**ADDENDUM NO. 3****Plans, Questions & Answers, Clarifications  
NEW AIR TRAFFIC CONTROL TOWER  
JEFFERSON MEMORIAL AIRPORT  
JEFFERSON CITY, MO**

To All Bidders: You are requested to make all changes and/or additions contained in this addendum to the Bidding Documents. Failure to acknowledge this Addendum in Proposal shall result in rejection of bid. Bidders are informed that the above referenced Plans are modified as follows as of May 14th, 2024:

**A-101**

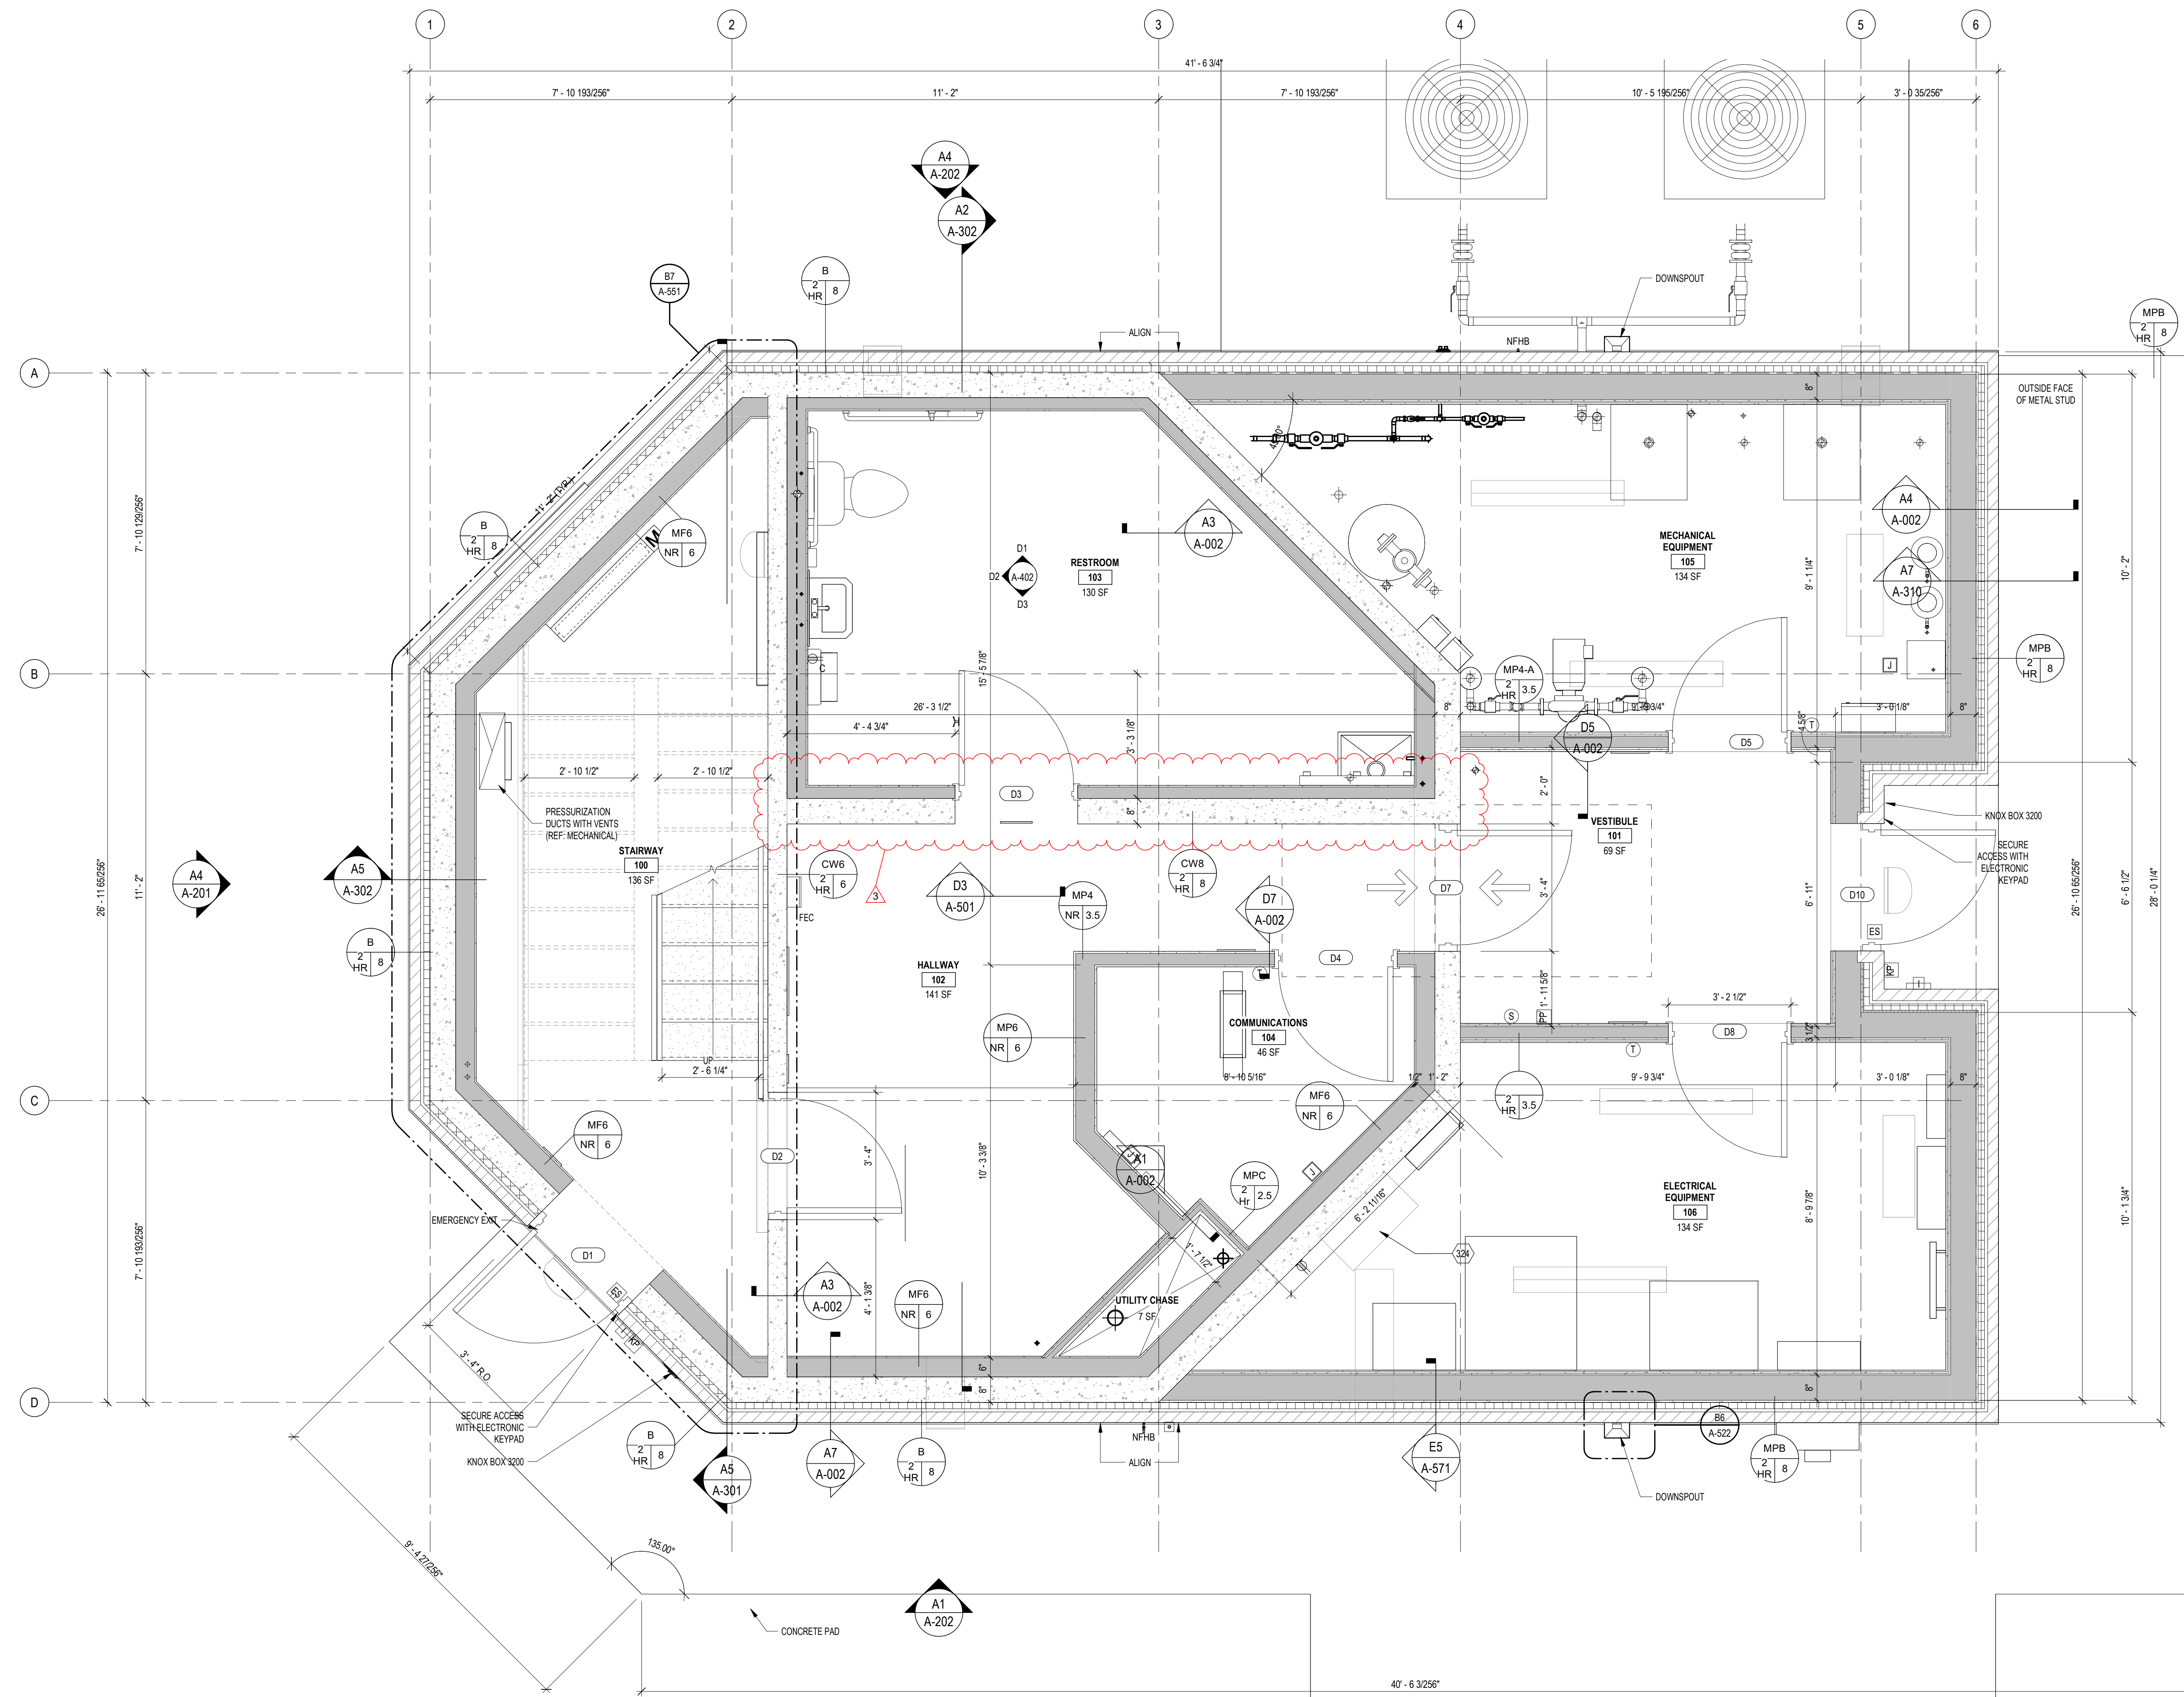
Added Precast Wall on interior side of Rest Room to match Structural Plans
